STAFF REPORT

SUBJECT: H-2020-0093
Oakwind Estates Subdivision – PP and MDA

LOCATION: Northeast Corner of N. McDermott Road and W. McMillan Road

A. Preliminary Plat (date: 9/1/2020)

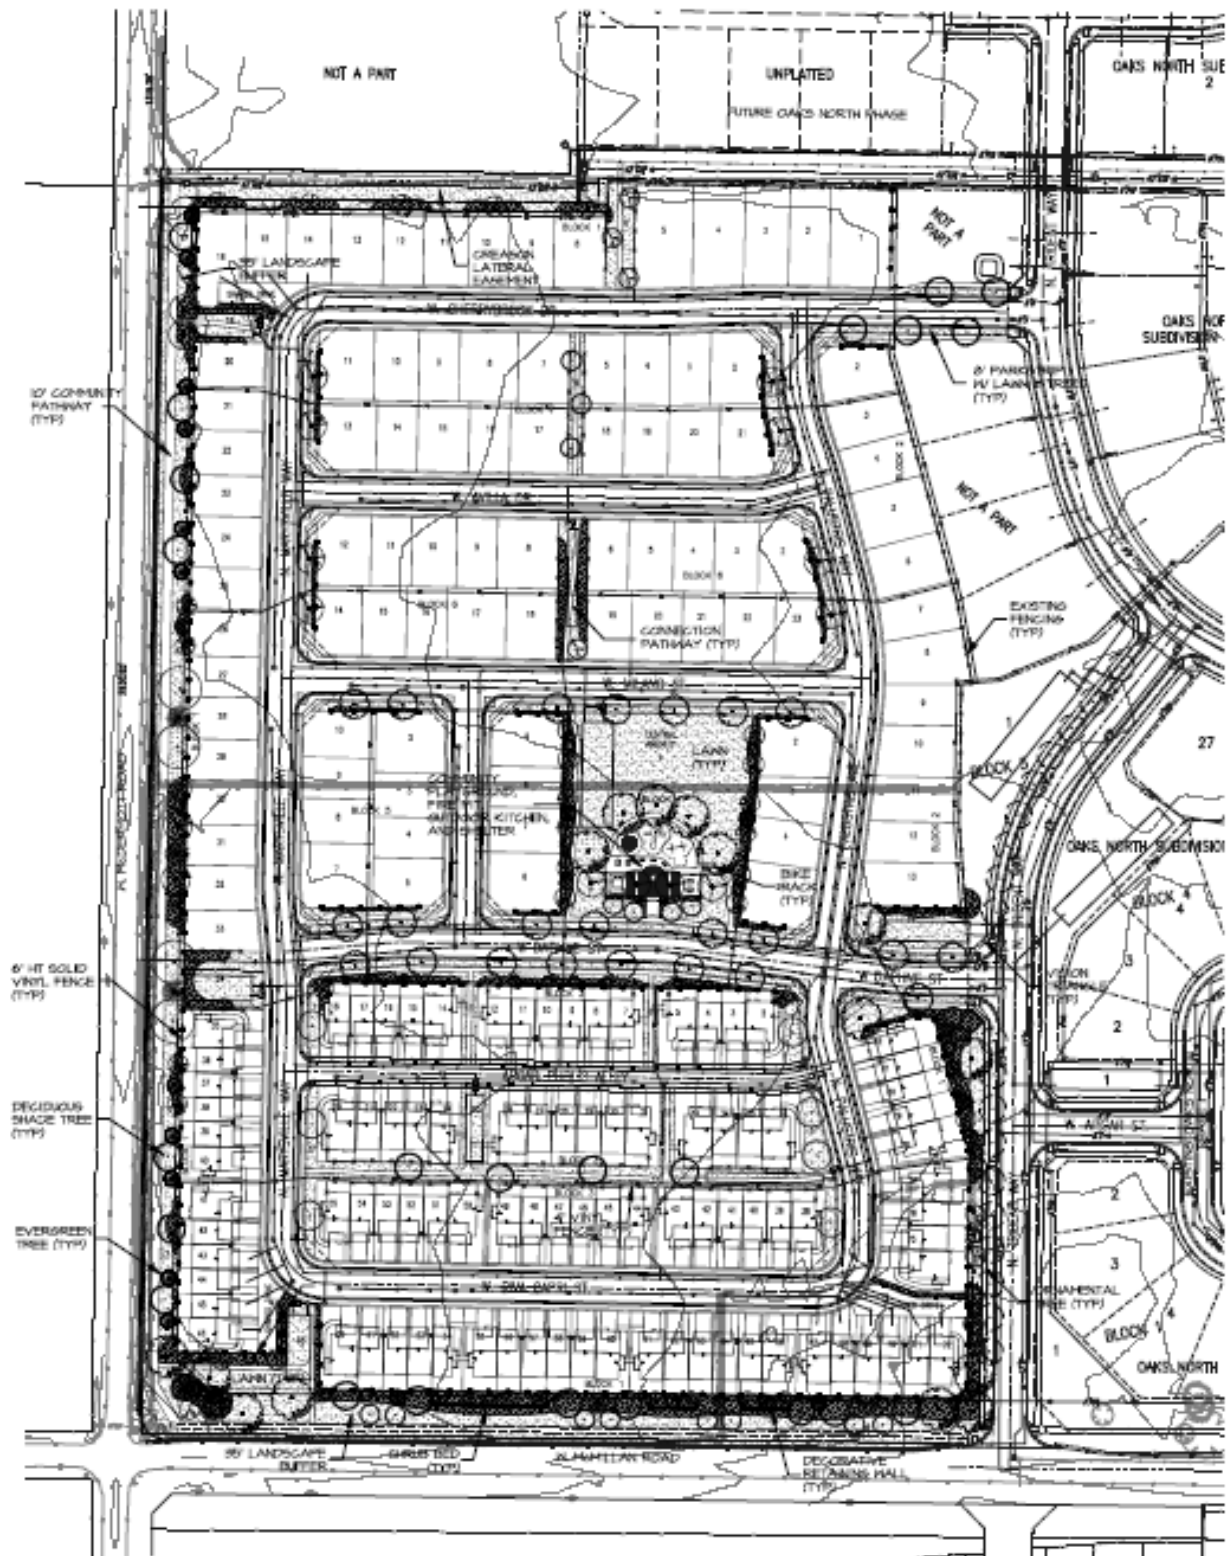
Per ACHD, Marysville Street and Palustris Avenue are proposed to be greater than 750-feet in length and will need to be redesigned to reduce the length of the roadways or to include the use of passive design elements. Stop signs, speed humps/bumps and valley gutter are not accepted as

traffic calming. Prior to City Council, the applicant should be required to submit a revised preliminary plat showing the redesigned roadways and approved by ACHD.

2. The preliminary plat included in Section VII.A, shall be revised ten (10) days prior to the Council hearing as follows:
 - a. Note #10: Revise to include Lot 84, Block 1 as a common lot to be owned and maintained by the Home Owners Association.

- b. Marysville Street and Palustris Avenue will need to be redesigned to reduce the length of the roadways or to include the use of passive design elements. Stop signs, speed humps/bumps and valley gutter are not accepted as traffic calming. The applicant shall submit a revised preliminary plat showing the redesigned roadways and approved by ACHD prior to City Council.

C. Landscape Plan (date: 9/1/2020)

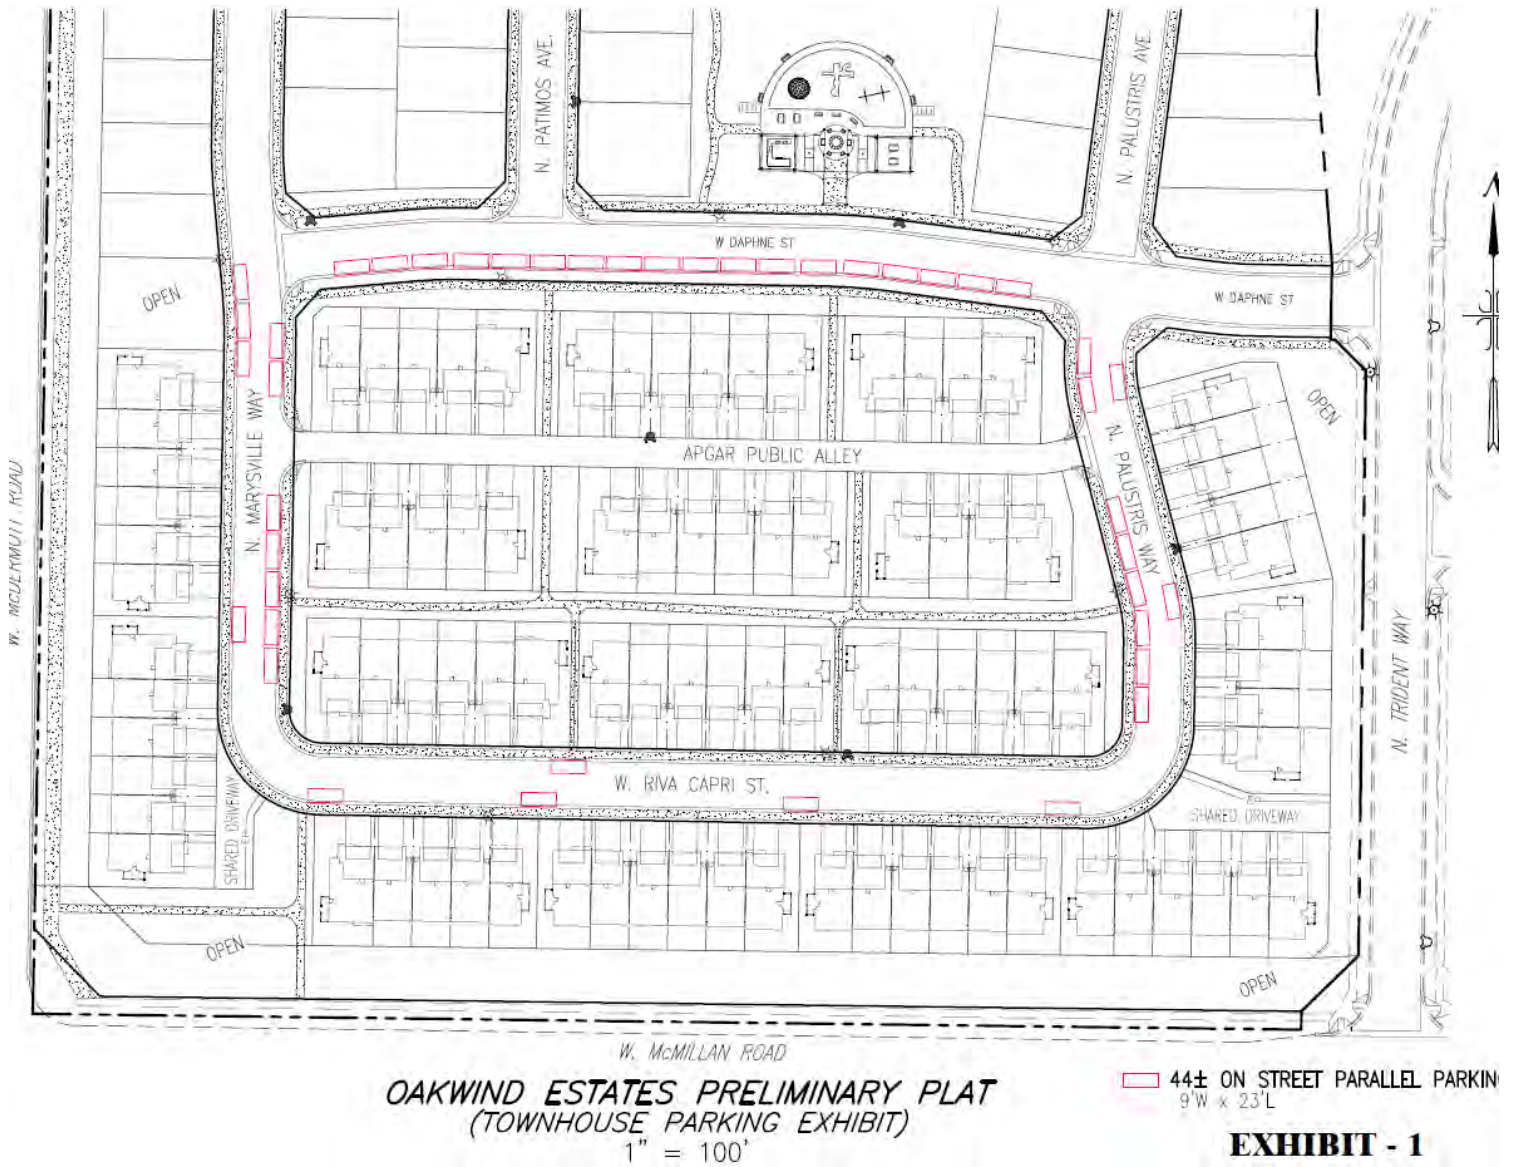
Finally, UDC 11-3H states residential development along McDermott Road from Chinden Blvd to I-84 is required to provide noise abatement by constructing a berm or a berm and wall combination a minimum of ten feet (10') higher than the elevation at the centerline approximately parallel to W. McDermott Rd. The landscape plan does not reflect this improvement. As a condition of approval, staff recommends the applicant submit a landscape plan which meets the requirements of UDC 11-3H-4D prior to City Council.

As mentioned in the section regarding access above, noise abatement by constructing a berm or a berm and wall combination a minimum of ten feet (10') is required along W. McDermott Rd. As a condition of approval, staff recommends the applicant submit a landscape plan which meets the requirements of UDC 11-3H-4D prior to City Council.

3. The landscape plan included in Section VII.B shall be revised ten (10) days prior to the Council hearing as follows:
 - a. The applicant shall revise the landscape plan to include a berm and sound attenuation wall along W. McDermott Rd as required in UDC 11-3H-4D. All required landscaping shall be on the west side of the wall.
